Access Compliance Report

Public Rights-of-Way

Intersection ID: 27949	Main Street: COLONIAL_COUNTRY_LN	Cross Street: WICKLOW_BROOK_CT	Location: S
ADA ID: DD5700CFDC19	Ramp Type: PerpDiag	Initial Pass/Fail: Fail	Overall Compliance: No
Severity Score: 10			
Codes/Mitigation Info/Possible Solution		Field Measurements/Component Compliance

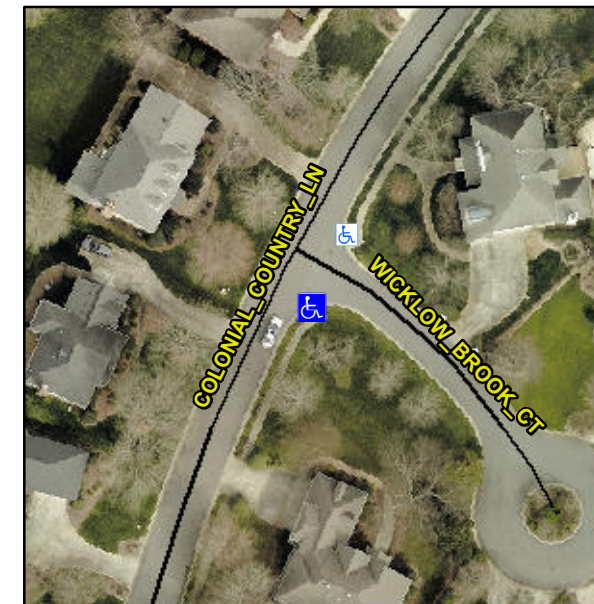
Not Found, R304.5.1, R304.5.3

Compliance	Description	Data	Compliance	Description	Data
N/A	Ramp Length (in)	89.0	Yes	Ramp Slope (%)	6.1
No	Ramp Width (in)	45.5	No	Ramp XSlope (%)	3.1
N/A	Flare Type LT	N/A	N/A	Flare Type RT	N/A
N/A	Flare Slope LT (%)	N/A	N/A	Flare Slope RT (%)	N/A
N/A	Flare Traversable LT?	N/A	N/A	Flare Traversable RT?	N/A
N/A	Landing Length (in)	N/A	N/A	DWS Provided?	N/A
N/A	Landing Width (in)	N/A	N/A	DWS Contrast?	N/A
N/A	Landing Slope (%)	N/A	N/A	DWS Length (in)	N/A
N/A	Landing X Slope (%)	N/A	N/A	DWS Full Width?	N/A
N/A	Landing Curb? (Y/N)	N/A	N/A	DWS Offset (in)	N/A
N/A	Shared Landing?	N/A			
N/A	Gutter Ponding?	N/A	N/A	Gutter Slope (%)	N/A
N/A	Gutter Lip Ht (in)	N/A	N/A	Gutter X Slope (%)	N/A
N/A	Painted X Walk1?	No	N/A	Painted X Walk2?	No
	X Walk 1 Direction	To NE		X Walk 2 Direction	To NW
N/A	X Walk 1 Width (in)	N/A	N/A	X Walk 2 Width (in)	N/A
	X Walk 1 Slope (%)	2.7		X Walk 2 Slope (%)	4.5
	X Walk 1 X Slope (%)	0.5		X Walk 2 X Slope (%)	0.5

Remove & Replace Curb Ramp With Two New Directional Ramps or Equivalent.
